- Subject** ▶ Changes on HANDLE SET and SCREWS which fasten the handle set
- For Models** ▶ JR3020(Recipro Saw) and 8406C(Diamond Core Hammer Drill)
- Description** ▶ The two parts in the subject have been changed for lower cost as described below;

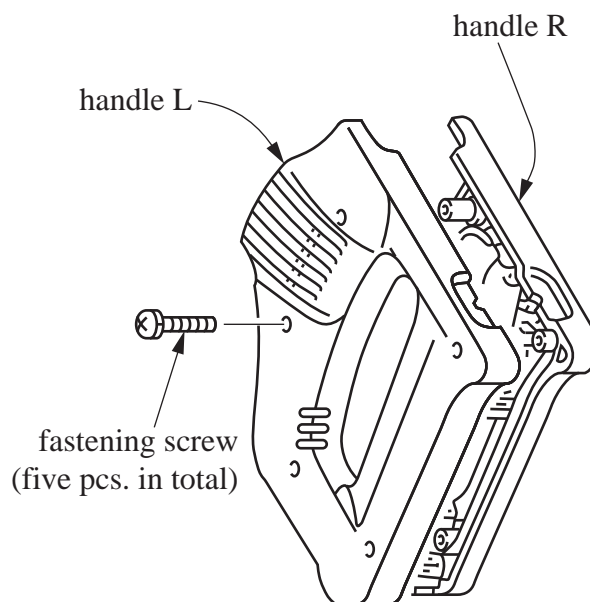
(1) Screws to fasten handle set (handle L and handle R) have been changed ;
from Pan head screw M4x30
to Tapping screw 4x25

(2) Holes/bosses of handle L/handle R have been changed to accept the tapping screws.

Item No.	Current part		Q'ty	I/C	New part		Q'ty	Note
	Handle set 182578-6		1	No	Handle set 182806-9		1	Interchangeable as a set
	Pan head screw M4x30 911158-9		5	No	Tapping screw Flange 4x25 265999-8		5

JR3020 : From serial No.17597E
8406C : From serial No.3403E
